THE ROVER COMPANY LIMITED

LAND-ROVER SERVICE NEWS LETTER No. 43

April 1964

Fig. 1. Flywheel reconditioning

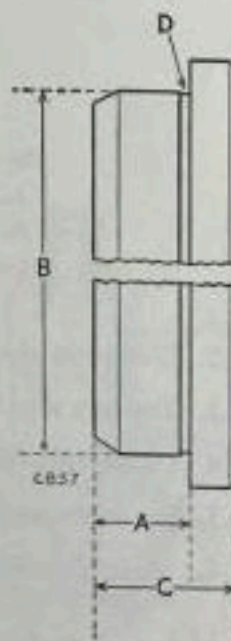
The chart below details flywheel machining dimensions for fitting ring gear part number 510489 to Series II and IIA Diesel models.

When machining the spigot diameter ensure machining is started from crankshaft flange face of flywheel as shown in the chart.

It is important that when refacing is carried out, all bolts and dowels are removed and the whole of the pressure face is machined.

Fig. 2. Oil fill and bleed points for steering relay housing

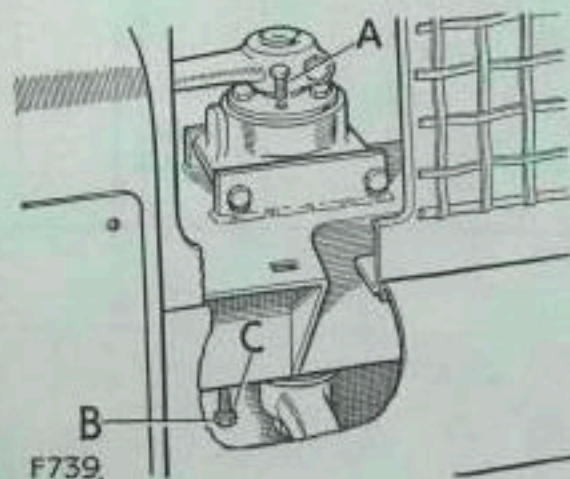
MODIFICATION: Introduction of steering relay shaft with the oilway and filler plug hole deleted.

REMARKS: The new relay can be identified by the absence of the filler plug in the top of the steering relay lever shaft. The following maintenance and assembly instructions apply to this new unit.

1. Fill unit with oil through any of the top oil seal housing fixing bolt holes, and bleed through the bottom oil seal housing fixing bolt hole in line with the boss on the relay housing. The bottom bolt to be sealed under the head with a suitable sealing compound. See Fig. 2.
